TO: Columbia River Crossing Project Sponsors Council
FROM: David Parisi, Facilitator, CRC Pedestrian and Bicycle Advisory Committee (PBAC)
SUBJECT: PBAC recommendation on bridge type, maintenance and security

Recommendation on bridge type, maintenance and security

Comparison of Pathway Options for I-5 Columbia River Bridge between Hayden Island and downtown Vancouver

3-BRIDGE

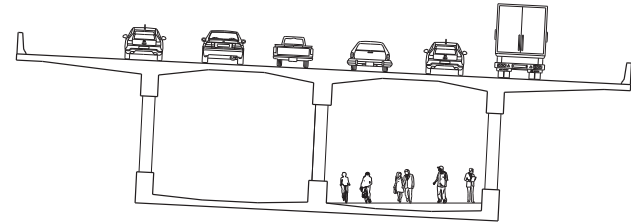
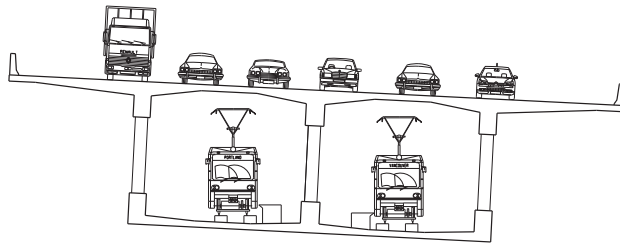
After a rigorous screening process over many meetings, PBAC recommends a two-bridge, covered path instead of the exposed path alongside highway traffic. Please see the attached matrix.

Option A: Three Bridge	Option B: Two Bridge Pathway under deck	Option C: Two Bridge Pathway on top deck	
SAFETY AND PERSONAL SECURITY				
“Eyes on the street”	ⓘ	○	●	Option A would have some visibility from light rail. Option C would have regular visibility from the highway.
Minimize exposure of pedestrians and bicyclists to vehicles and/or transit	ⓘ	●	○	Option A exposes pathway users to light rail. Option B would not expose pathway users to motorized traffic and transit. Option C exposes pathway users to highway traffic.
Separate pedestrians and bicyclists	ⓘ	●	ⓘ	Option B, the widest, would provide the most potential for separation between modes.
Separate “commuter” and “recreational” bicyclists	ⓘ	●	○	Option B, the widest, would provide the most potential for separation between different types of bicyclists.
Reduce/eliminate at-grade crossings with vehicles and transit	S	S	S	All options would provide a grade separated pathway.

Provide railings between users and vehicles/transit and water	S	S	S	All options would provide barriers and railings that meet current height standards.
Provide sufficient pathway lighting	S	S	S	Compared to Option B, Options A and C would provide better lighting during daylight, but worse at night.
Potential to provide security cameras and phones	S	S	S	All options have the potential to provide security cameras and phones.
Potential to post ordinances, applicable laws and agency contact information	S	S	S	All options could post applicable laws, ordinances and agency contact information.
DESIGN				
Exceed ODOT/WSDOT multi-use path ‘desirable’ width standards (16 feet)	ⓘ	●	○	Option A: one 16’ path, Option B: one 24’ path, Option C: two 12’ paths. Standard ODOT/WSDOT multi-use path widths are 14’.
Comply with ADA standards for grade (≤ 5%) and cross-slope (≤ 2%)	S	S	S	All options would meet ADA standards for grade and cross-slope.

Maximizes design principles of Crime Prevention Through Environmental Design (CPTED)	ⓘ	○	●	CPTED principles performance increases as multi-use pathway user visibility is maximized.
Minimizes elevation of path over river and changes in grade. Ability to maximize proximity to river.	○	ⓘ	○	Option B would have the lowest multi-use pathway height that meets Coast Guard navigation standards.
Minimize travel on long grades	ⓘ	●	○	Travel time on long grades increase as height of pathway increases.
Maintain required sight distances for applicable design speeds	S	S	S	All options would have the required sight distance for the applicable design speed.
Minimize turns and provide for comfortable turning on access/egress ramps	ⓘ	●	ⓘ	Option B would have fewer turning areas on ramps than Options A or C.
Meet overhead clearance standards (10 feet)	S	S	S	All options would meet the clearance standard.
Potential to be constructed with non-skid surfaces for traction	S	S	S	All options could use non-skid surfaces.

Planned for future capacity, flexibility and versatility	ⓘ	●	○	All options could accommodate forecasted demand. Option B provides the most flexibility for accommodation.
Ability to provide emergency response/maintenance vehicle access to the pathway	ⓘ	ⓘ	●	Option C would provide the easiest access as it is adjacent to the highway. All options would be accessible to emergency response and maintenance vehicles.
Potential maintenance and operations costs	●	○	ⓘ	Option B would likely have slightly higher operating costs because it would require more maintenance and security upkeep.
Overall cost	ⓘ	●	○	Option B is the lowest cost to build because it requires less structure cost than Option A or C. Option A would be at least \$50M more, and Option C would be at least \$75M more.

2-BRIDGE (STACKED/UNDERDECK)

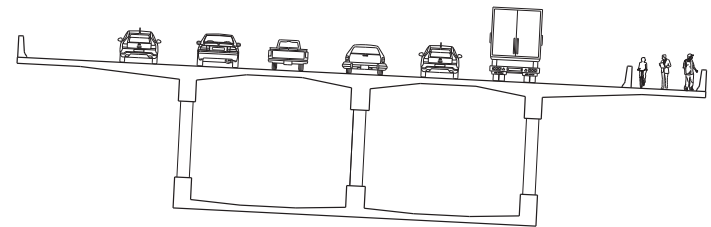
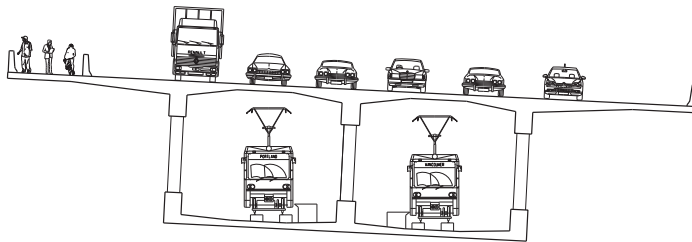
“Provided the Columbia River Crossing Project Sponsors Council makes a commitment to PBAC’s recommendation for a maintenance and security program, the PBAC would support the two-bridge, covered path option.”

Wind protection	○	⓪	○	Option B provides the most wind protection because the under deck location and the top deck overhang reduce exposure to wind.
Rain protection	○	●	○	Option B provides the most rain protection because of the under deck location and overhang reduce exposure to rain.
Headlight glare protection	⓪	●	○	Option B provides the most headlight glare protection because it is separated from vehicle and transit traffic.
Potential for natural light, open sky crossing and sense of openness	●	⓪	●	Options A and C would be open to the sides and above. Option B would be open to the sides but not above.
Ability to "program the space" and provide activity areas	⓪	●	○	Better opportunities to 'program the space' and involve people would exist with Option B because the design affords protection from the elements.
Provides scenic views from the bridge of: Mt. Hood, Columbia River, Hayden Island, and Downtown Vancouver	⓪	○	●	All options would provide opportunities for scenic vistas, but Option C would have the most unrestricted views.

We are pleased to report back to you that the Project Sponsors Council, which includes ODOT and WSDOT, unanimously accepted the PBAC recommendation at their September meeting. Each member confirmed their agency's commitment to developing a maintenance and security plan as outlined by PBAC.
